## **BP Makes a fresh proposal for a Petrol Station and Food Outlet to the west of Udimore Road at TN31 6AA on a .6 Ha sit: February 2018**

<b>Reference</b>	RR/2018/545/P
<b>Status</b>	Undecided
<b>Proposal</b>	Construction of petrol filling station, canopy, sales building, ATM, AC/refrigeration units, refuse compound, parking and associated works.
<b>Location</b>	Udimore Road - Land North of, Rye TN31 6AA
<b>Parish</b>	RYE
<b>Case Officer</b>	Mr J McSweeney
<b>Received</b>	13-02-18
<b>Validated</b>	26-02-18
<b>Decision By</b>	28-05-18
<b>Applicant</b>	BP Oil UK Limited Witan Gate House Milton Keynes MK9 1ES
<b>Agent</b>	Aitchison Rafferty Attn: Mr Nigel Ozier The Granary Spring Hill Office Park Harborough Road, Pitsford, Northampton NN6 9AA

AONB is in light green; other protected areas are hashed

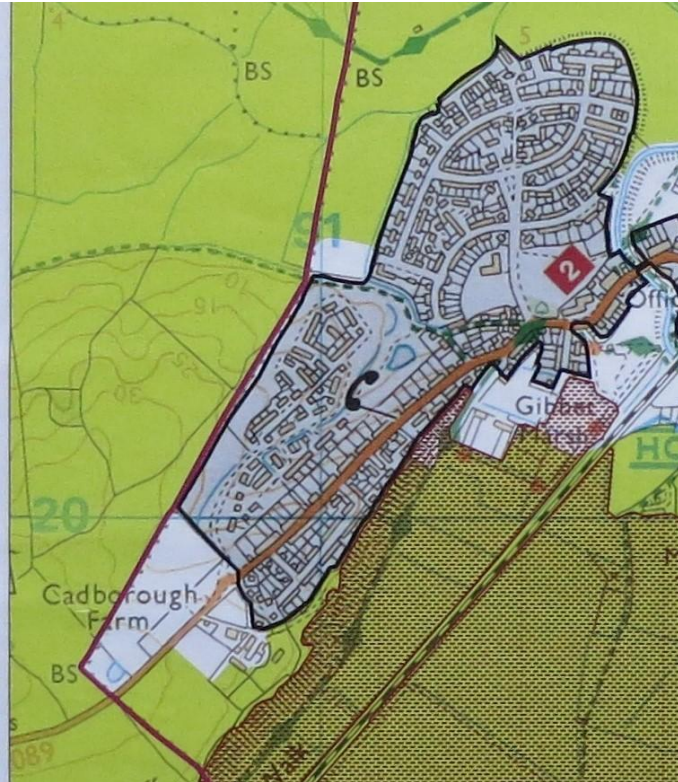
13. AR acknowledges the proximity of the AONB to their proposed site but argues that, despite the height and prominence of the land, further measures – more than moving the development as proposed 6m to the East - can be taken to reduce the impact of development on it. AR notes that the Inspector when considering the Valley Park (SHLAA 2013 RY5) development found that the impact on the AONB of the housing development on lower ground was acceptable. But, AR declines to note (Application 3.5) the other key remark, which was that because development in RY5 was much lower than the land subject to AR’s proposal, it was felt that “it could be contained within the landscape and sit comfortably within the context of the adjoining development”. Can this be argued for the new proposal?

Figure 1 Site plan under proposal

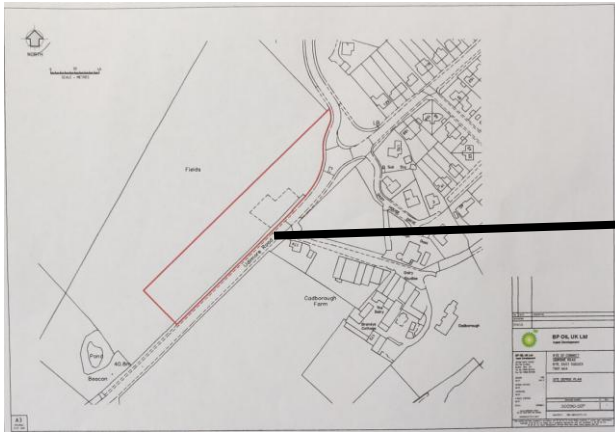
1. Aroncorps is developing the 10.87 hectare greenfield site known as Valley Park, initially approved for 135 dwellings, but subsequently increased to 165 in 5 phases. Around 4 hectares of the total site are being developed.
2. The development boundary (Figure 2) does not include an extension of the Aroncorps site on the west side of the roundabout, which rises to the high ground and the Rye Parish boundary. This site (Figure 1 – Red) is the subject of a further planning proposal.
3. The site sits to the north of one of the “gateways” to Rye from the West, close to the boundary of the AONB. In common with Valley Park, this site is a green space comprising mainly old pasture over clay. There is some old hard standing, formerly used for agricultural purposes. Drainage is complicated by springs, ponds and the impervious clay.

Figure 3 Proposal Plan

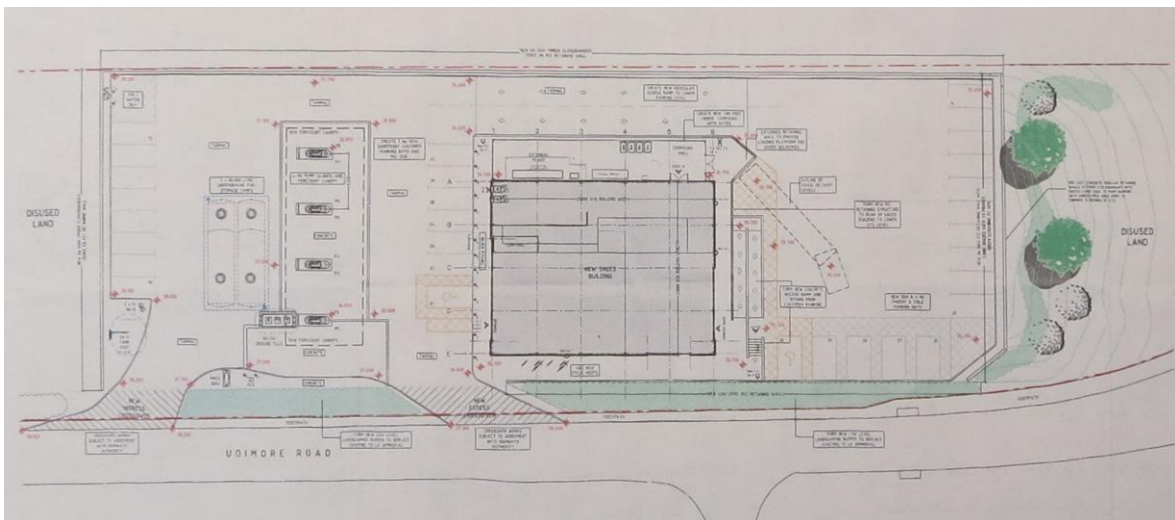
6. One reason for this opposition is that the RNP seeks to check development at the extremities of the Parish on sites just beyond or on the settlement boundary to ensure that the gateways to the Town are not adversely affected and that the unique character of Rye is preserved. There are several current proposals affecting other gateways in the Parish: Rye Hill (sites in Rye Foreign immediately adjacent the Parish Boundary), the tennis club on the Military Road and now this site. In addition there has for many years been informal development in the strategic gap to Rye Harbour. All this is seen to add “urban creep” into the green spaces surrounding Rye Parish, adversely impacting on the character of Rye and its place in the environment.

9. The 2008 argument by the Planning Inspector above is considered relevant, because it cannot be applied to this new proposal. Even with landscape and lighting mitigation, on such an elevated site, it would not *“be contained within the landscape and sit comfortably within the context of the adjoining development”*.

10. Rather, this proposal could be seen as further “urban creep” (both by structure, lighting and noise) that would impact adversely on one of the gateways into Rye and in turn on Rye’s unique character and profile in its marsh surroundings, including the adjacent AONB.
